This document contains proposed changes to subclause 87.8.11 and 88.9.10.

Subclause 87.8.11 in Draft 2.1 is:

Change this to become:

Figure 87-3—Stressed receiver conformance test block diagram

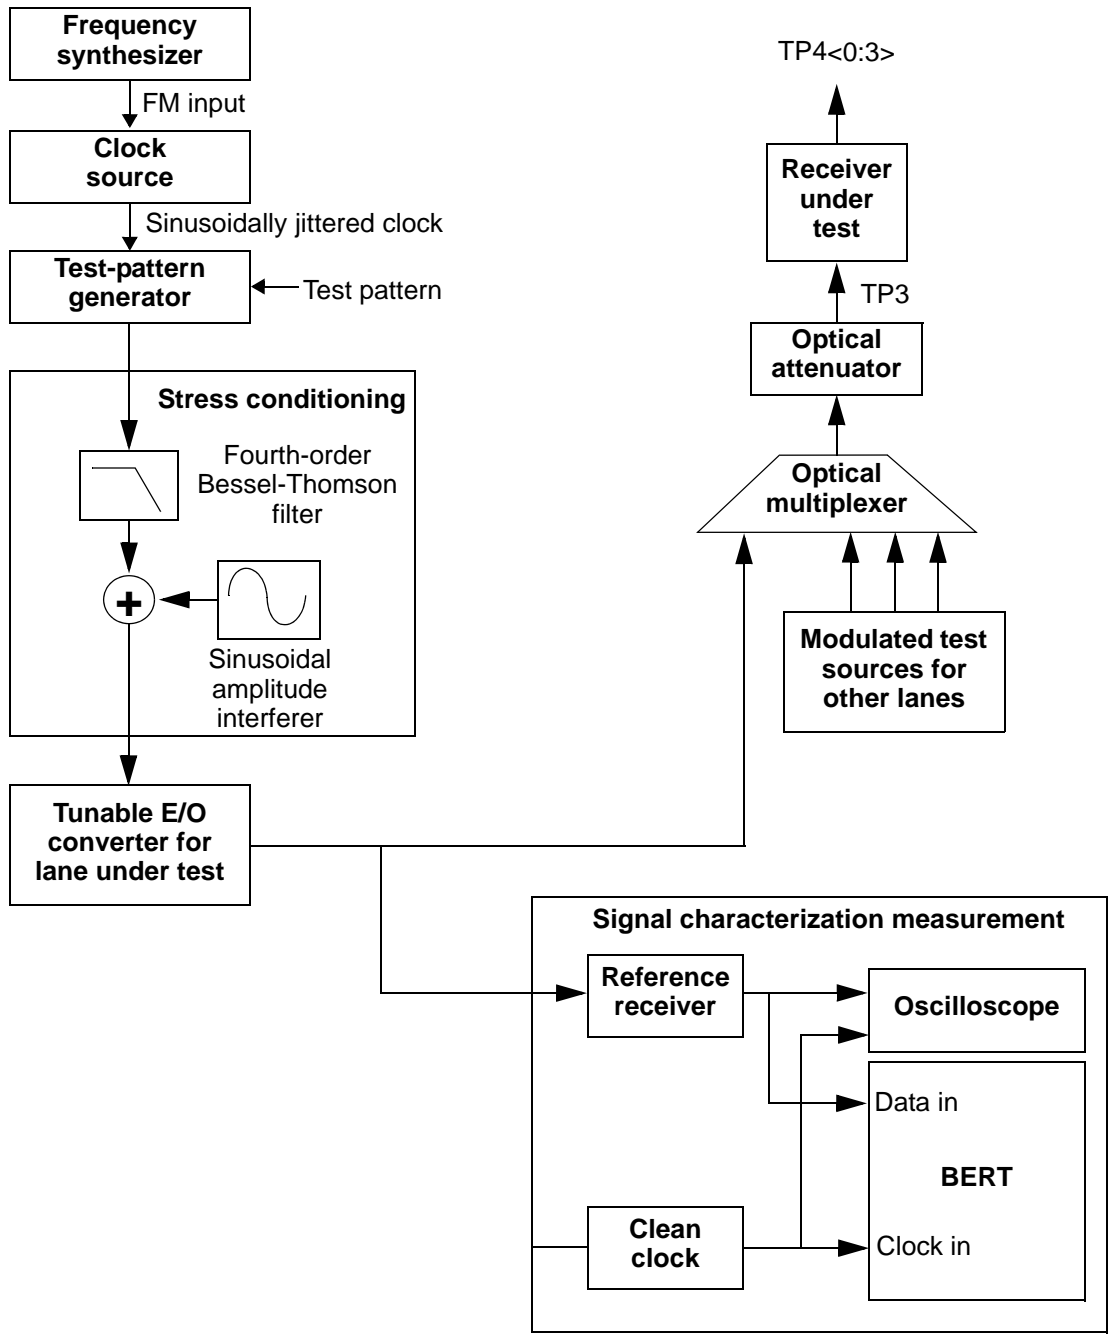
A block diagram for the receiver conformance test is shown in Figure 87–3. The test pattern is specified in Table 87–11. The optical test signal is conditioned (stressed) using the stressed receiver methodology defined in 87.8.11.2, and has sinusoidal jitter applied as specified in 87.8.11.4.

The fourth-order Bessel-Thomson filter is used to create ISI-induced vertical eye closure penalty (VECP). The Bessel-Thomson filter, when combined with the E/O converter, should have a frequency response which results in the appropriate level of initial vertical eye closure before the sinusoidal terms are added.

The sinusoidal amplitude interferer causes additional eye closure, but in conjunction with the slowed edge rates from the filter, also causes jitter intended to emulate Duty Cycle Distortion (DCD). DCD cannot be created by simple phase modulation alone. The sinusoidally jittered clock represents other forms of jitter and also verifies that the receiver under test can track low-frequency jitter.

The sinusoidal amplitude interferer may be set at any frequency between 100 MHz and 2 GHz, although care should be taken to avoid harmonic relationships between the sinusoidal interference, the sinusoidal jitter, the data rate and the pattern repetition rate.

For improved visibility for calibration, the Bessel-Thomson filter and all other elements in the signal path (cables, DC blocks, E/O converter, etc.) should have wide and smooth frequency response, and linear phase response, throughout the spectrum of interest. Baseline wander and overshoot and undershoot should be minimized. Random noise effects, such as RIN and random clock jitter, should also be minimized. Some residual noise and jitter from all sources is unavoidable, but should be less than 0.25 UI peak-peak jitter at the 10^{-12} points. If this is achieved, then data dependent effects should be minimal, and short data patterns can be used for calibration with the benefit of providing better trace visibility on sampling oscilloscopes.

Figure 87-4—Required characteristics of the conformance test signal at TP3

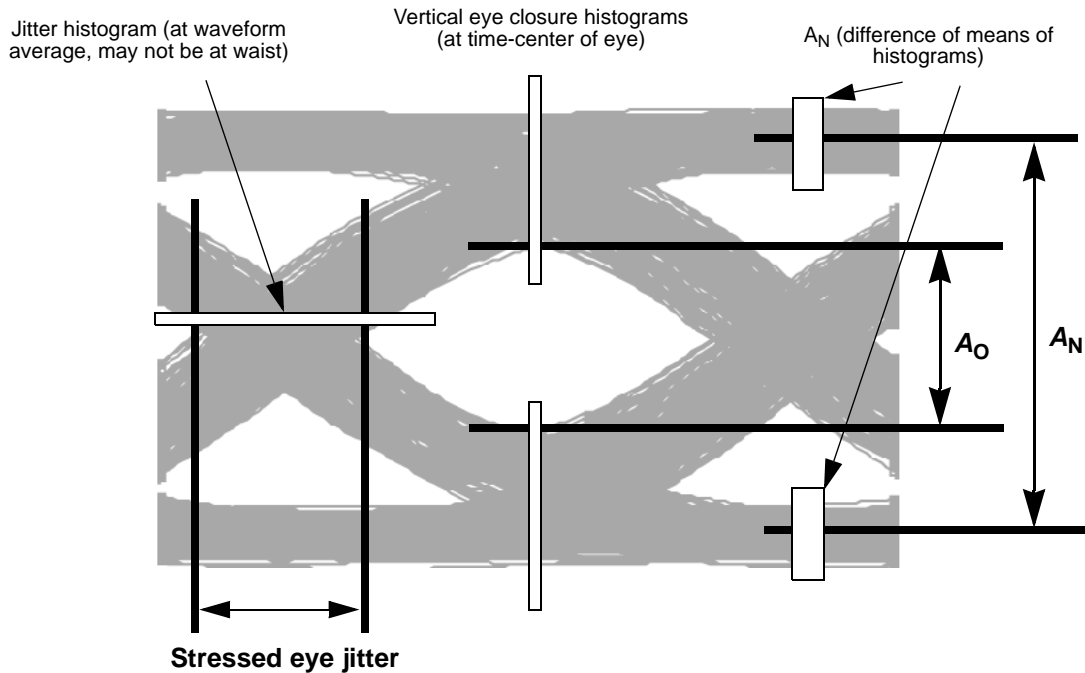
The primary parameters of the conformance test signal are vertical eye closure penalty (VECP) and stressed eye jitter (SEJ). Vertical eye closure penalty is measured at the time center of the eye (halfway between 0 and 1 on the unit interval scale as defined in 52.9.7). The stressed eye jitter is defined from the 0.5th to the 99.5th percentile of the jitter histogram and is measured at the average optical power, which can be obtained with AC coupling. The values of these components are defined by their histogram results.

The vertical eye closure penalty is given by Equation (87–1).

$$\text{Vertical eye closure penalty [dB]} = 10 \times \log \frac{A_N}{A_O} \quad (87-1)$$

- A_O is the amplitude of the eye opening from the 99.95th percentile of the lower histogram to the 0.05th percentile of the upper histogram, and
- A_N is the normal amplitude without ISI, as shown in Figure 87–4.

Figure 87-5—Illustration of the mask of the sinusoidal component of jitter tolerance

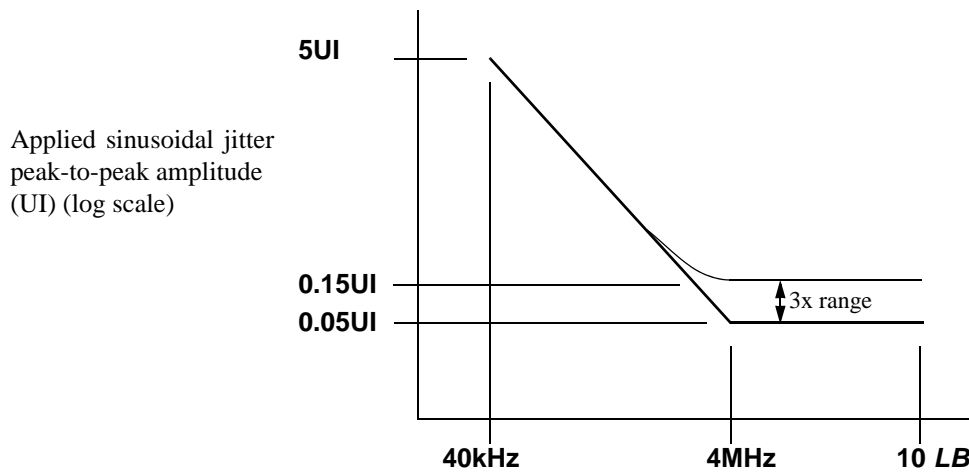
Sinusoidal jitter is added as specified in Table 87-13. When calibrating the conformance signal, the sinusoidal jitter frequency should be well within the 4 MHz to 10 times LB as defined in Table 87-13 and illustrated in Figure 87-5.

The sinusoidal jitter is used to test receiver jitter tolerance. The amplitude of the applied sinusoidal jitter is dependent on frequency as specified in Table 87–13 and is illustrated in Figure 87-6.
